Item 5.**Development Application 806-812A George Street, Haymarket - D/2025/33****File Number:** D/2025/33**Summary**

Date of Submission:	21 January 2025
Applicant:	C Zeng-Allen
Architect/Designer:	MKD Architects
Developer:	Bounce Sydney Investments
Owner:	Fuqiang Investments Pty Ltd
Planning Consultant:	Gyde Consulting
Heritage Consultant:	Weir Phillips Heritage
DAPRS:	1 April 2025
Cost of Works:	\$26,751,299.00
Zoning:	The site is located within the SP5 – Metropolitan Centre zone. The use is defined as "Backpackers Accommodation", and "Hotel accommodation" with associated café and bars, and is permissible with consent within the zone
Proposal Summary:	Approval is sought for the demolition of the existing buildings with partial retention of the existing facade, and construction of 11 levels of backpackers accommodation and one level of hotel, comprising 577 backpacker beds and 8 hotel rooms, with ancillary ground level bar, cafe and two storey rooftop bar with associated outdoor area and swimming pool, and new basement level for building services and waste storage.

Summary Recommendation: This proposal is recommended for refusal.

Figure 23: Street frontage and setbacks map under Figure 5.9 of the DCP, showing the subject site

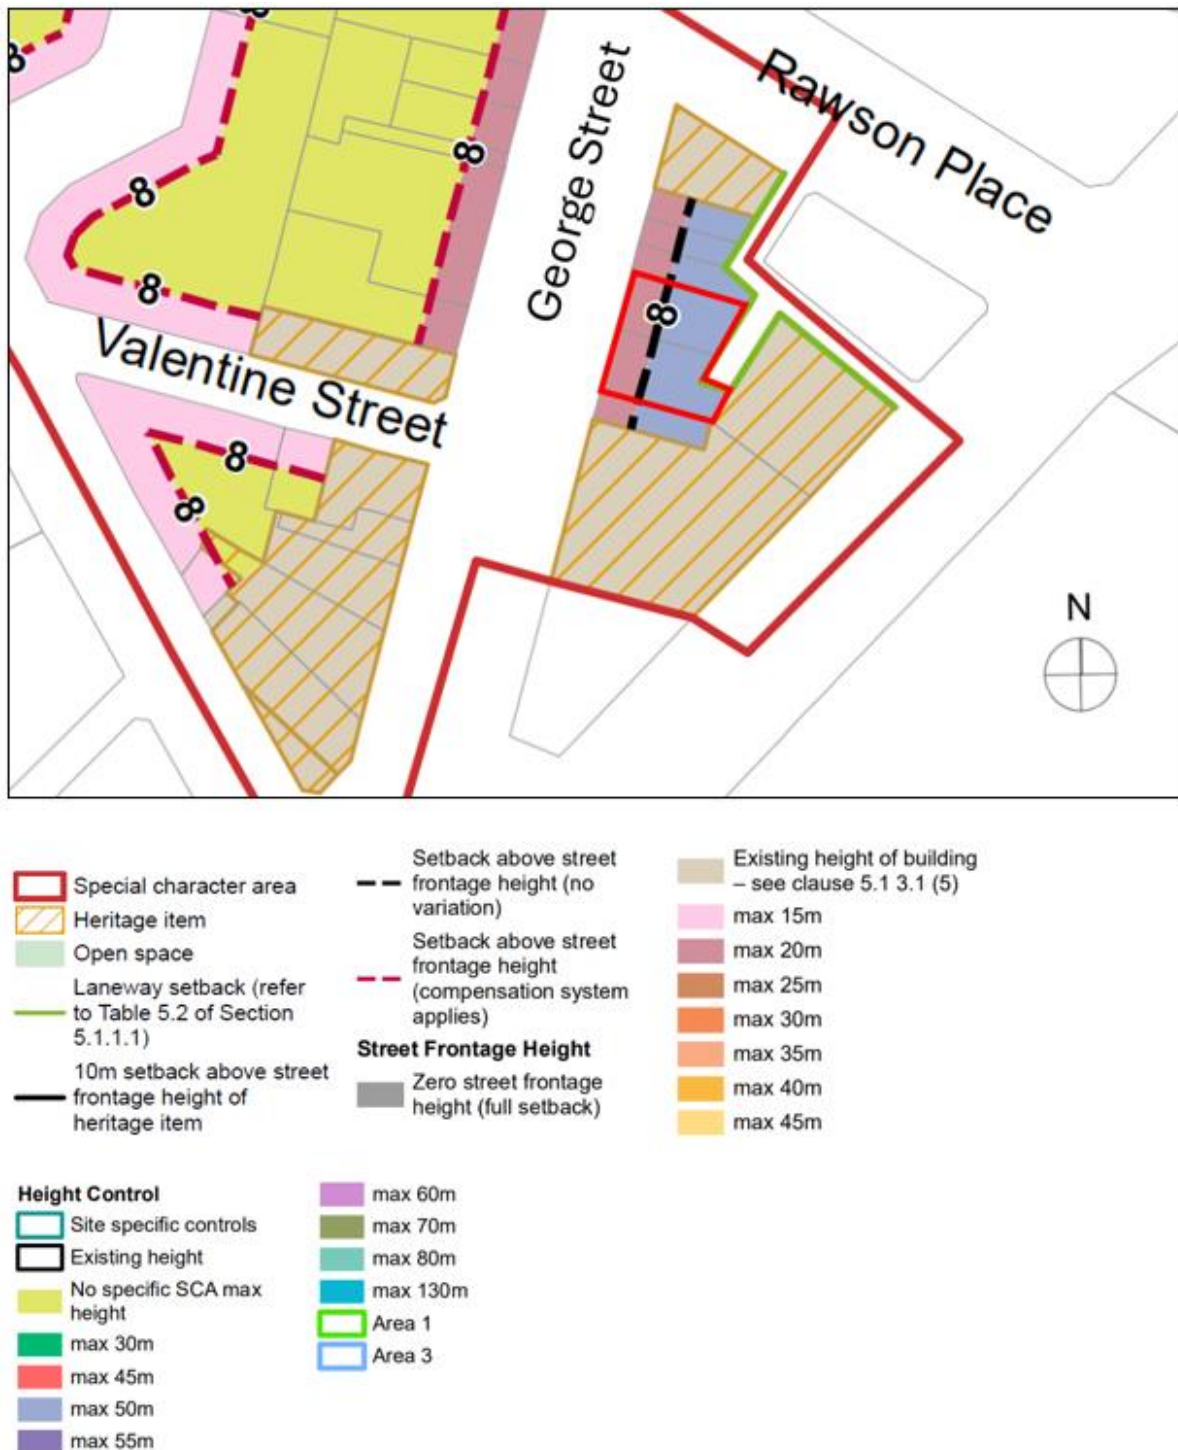
64. The site is located within the Haymarket/ Chinatown Special Character Area under the DCP.
65. Section 5.1.1 of SDCP 2012 requires a street frontage height for new buildings located within the Haymarket/Chinatown Special Character Area of no greater than 20 metres above ground level, with a minimum setback of 8 metres above the street frontage height to George St for the site. The DCP also specifies that no variation is permitted to the required 8m setback for the subject site.

66. The proposal retains the existing George Street facade which provides a street wall height of approximately 13.5m to the top of the parapet and complies.
67. As the proposed building is less than 55m in height, there are no minimum side or rear setback requirements under the DCP controls.

Figure 24: Site survey showing 6m and 8m setbacks from George St in relation to Christ Church St Laurence

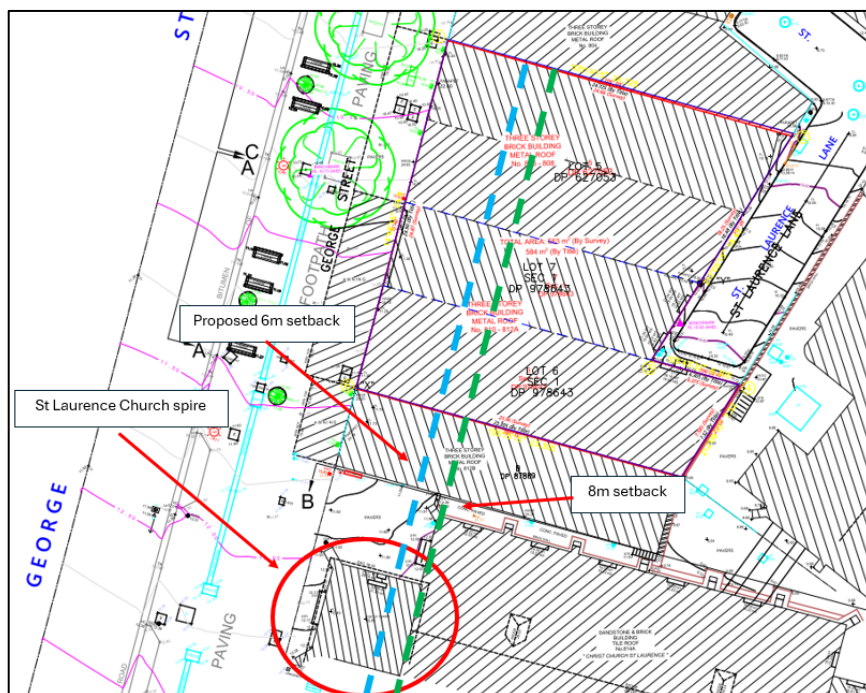
71. The submitted DA package includes a view analysis from the surrounding streets of a complying building envelope (setback 8m above street frontage height). However, it is noted that no comparison images have been included in the analysis which show the proposed building envelope with a reduced 6m setback to George St. The submitted site survey indicates that the rear of the church spire is setback 8m from George St as shown below.

Figure 25: View analysis by applicant depicting a compliant building envelope, looking south along George St from the intersection with Ultimo Rd

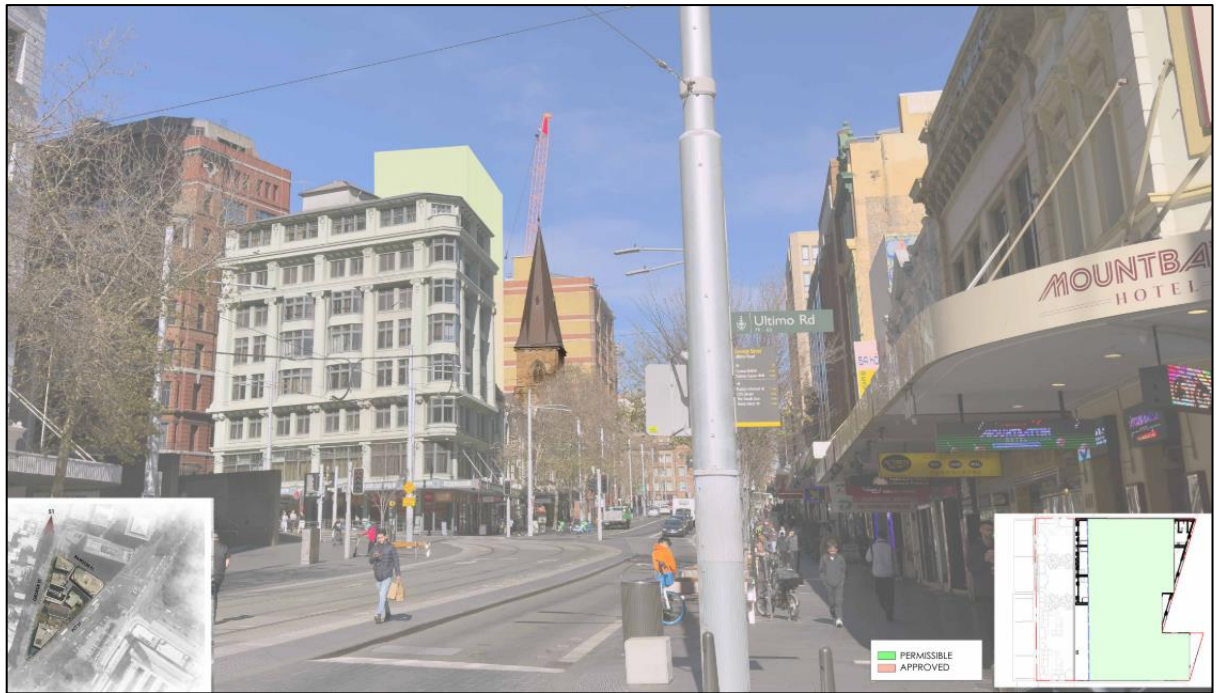
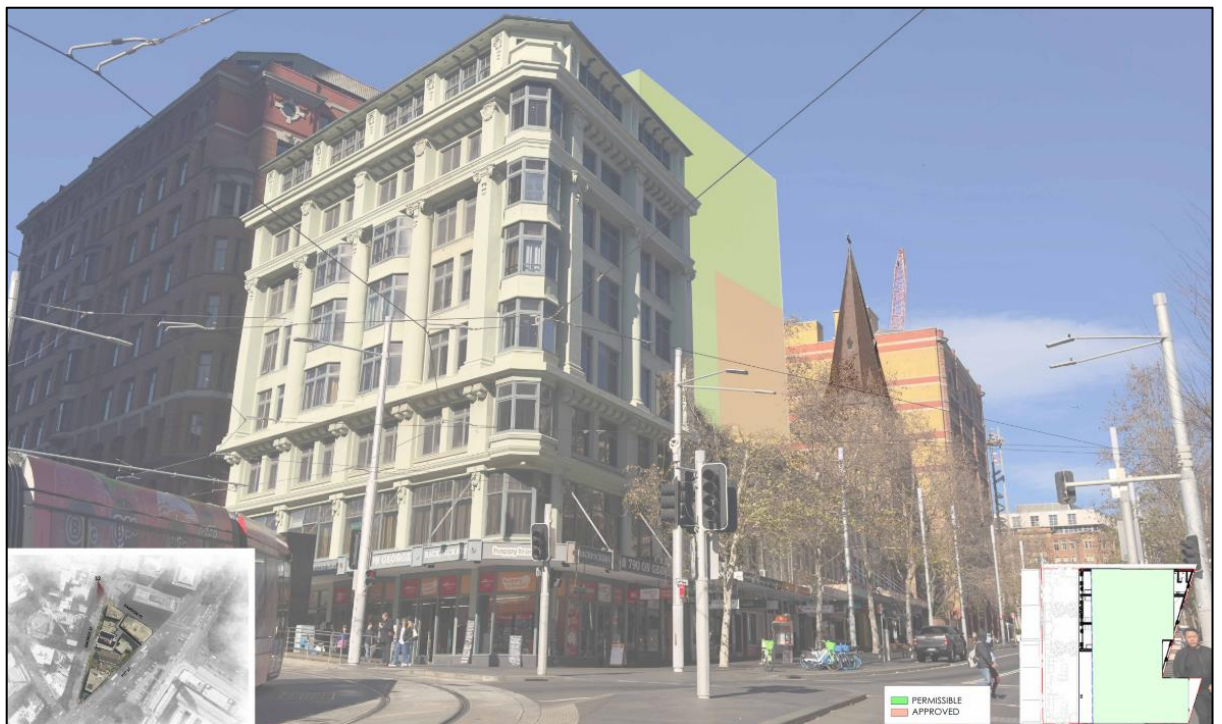
72. The above view analysis indicates that a compliant building envelope setback 8m from George St above the street wall will allow the spire of Christ Church St Laurence to be viewed in its entirety when looking south along George St. However, as no comparison images have been submitted to show the proposed building envelope, it is unclear as to the extent of visual impacts the proposed 6m setback would have on the setting, prominence and views of the church spire. The reduced 6m setback would set an undesirable precedent for the three neighbouring properties to the north at No.800-804 George St, and the adjoining property to the south at No.812B George St, which are all part of the same row of buildings and are currently undeveloped. Therefore, the non-compliance with the setback above street frontage height control is not considered to meet the objectives of the controls, and does not result in a better planning outcome considering the context of the subject site within the special character area.

Figure 27: Proposed Level 2 plan showing partition walls abutting the windows of the existing facade

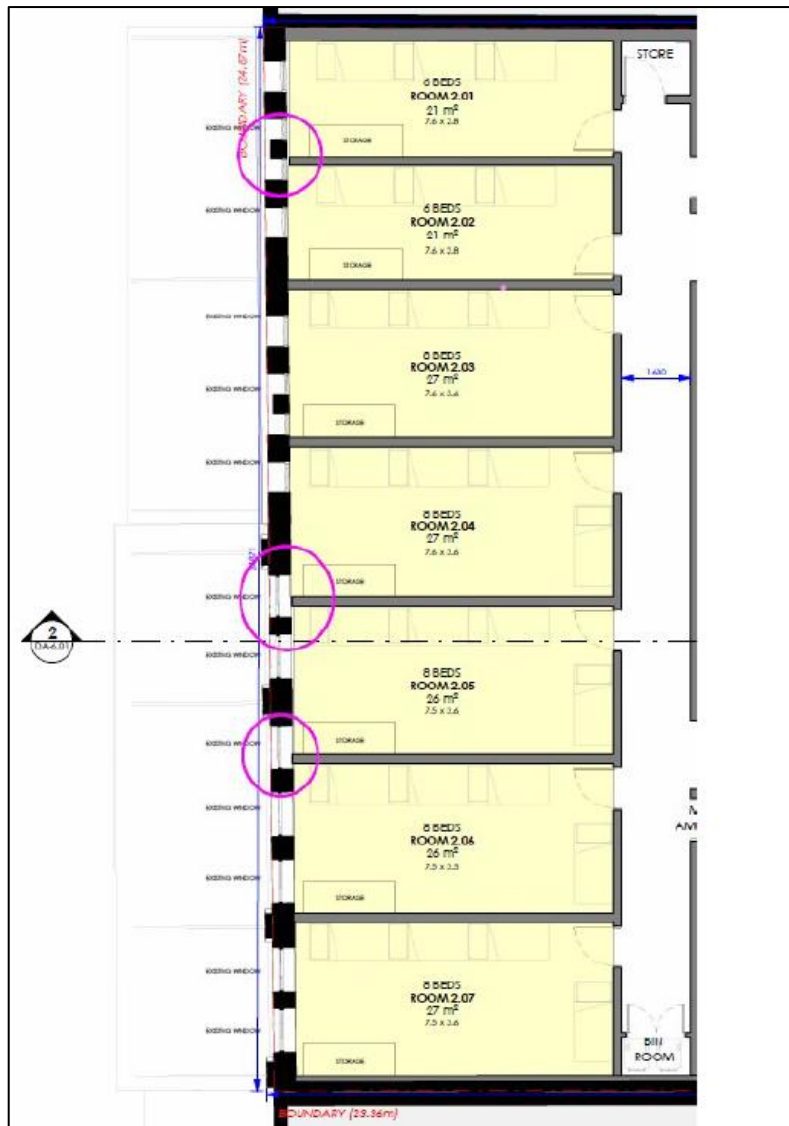
76. There are also concerns with the proposed interface of the new building with the existing retained George Street facade. The internal partitions of the backpacker rooms on Levels 1 and 2 do not align with the existing windows, and as a result the internal dividing walls abut the window openings as demonstrated in the below figure.

Figure 28: Front parapet of No.806-808, showing the relative location of the Level 3 floor slab in pink

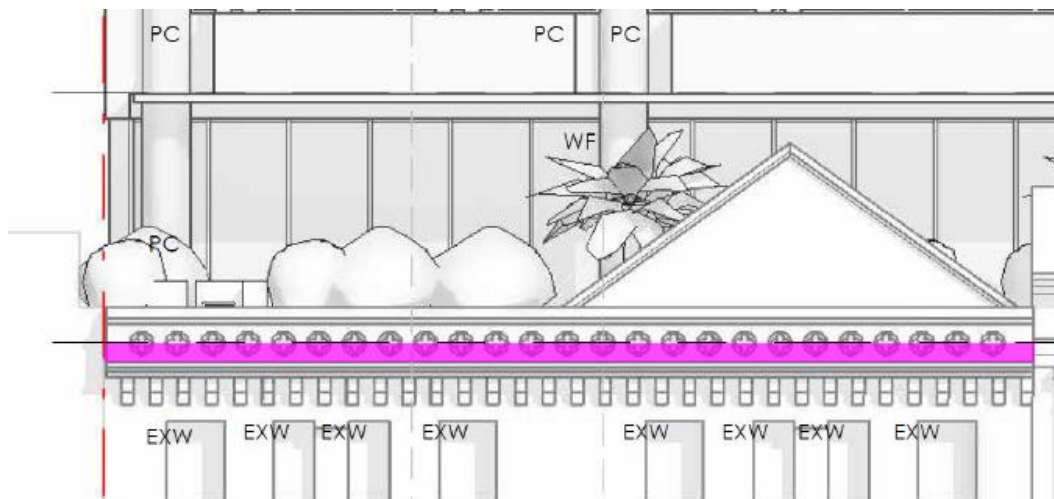
77. It is also noted that the existing northern building at No.806-808 sits at a lower level than the southern building at No.810-812A. The submitted plans do not show the RLs of the existing floor levels across both buildings. As the existing buildings have awnings and windows which do not align across the entire frontage, it is likely that existing floor levels vary between the two buildings. The proposal provides consistent floor levels across the width of the building on Levels 1 and 2, and the architectural plans do not provide a cross section through the northern portion of the building to show the relationship between the proposed floor levels and retained facade and window openings. Therefore, there is insufficient information to assess whether the proposed floor levels are appropriate relative to the retained facade. It is also unclear how the Level 3 terrace slab interfaces with the existing decorative parapet to George St at No.806-808, given it is at a lower level than the parapet to No.810-812A, as demonstrated in the below figure.

Figure 29: Level 12 plan highlighting the area of void and risers

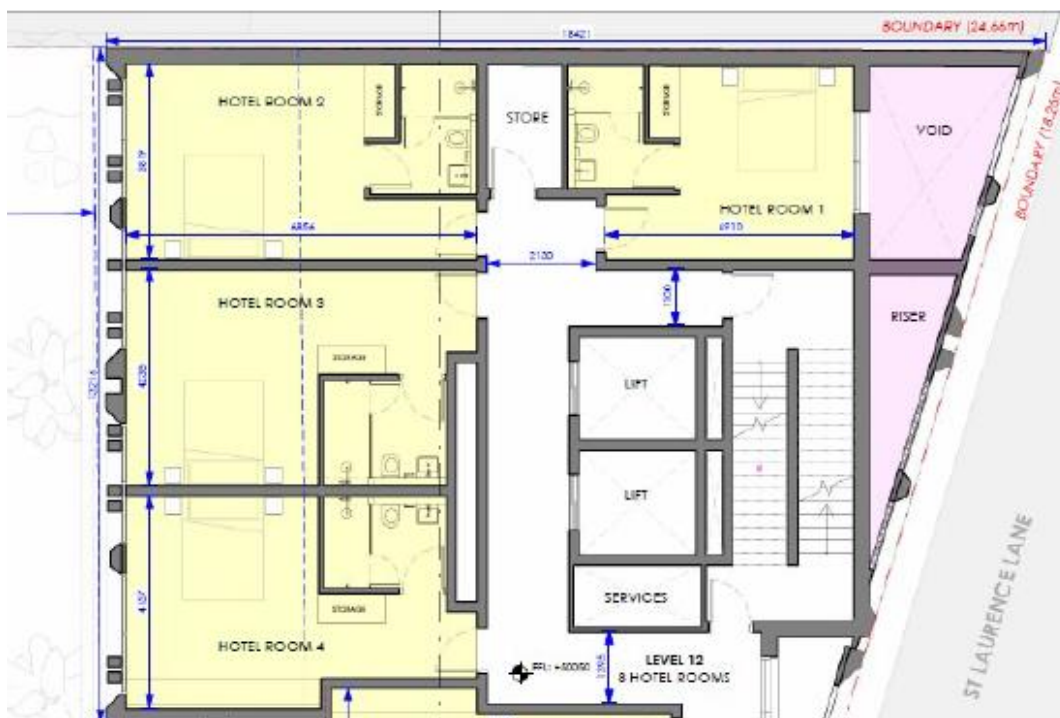
80. It is also noted that hotel room 1 on Level 12 relies on an enclosed internal void for natural light and ventilation. This void and the adjoining riser extend to Level 14 as depicted in the below figures.

81. In addition to reducing the amenity to hotel room 1, the enclosed void and risers results in unnecessary bulk to the rear (St Laurence Lane) elevation of the building.
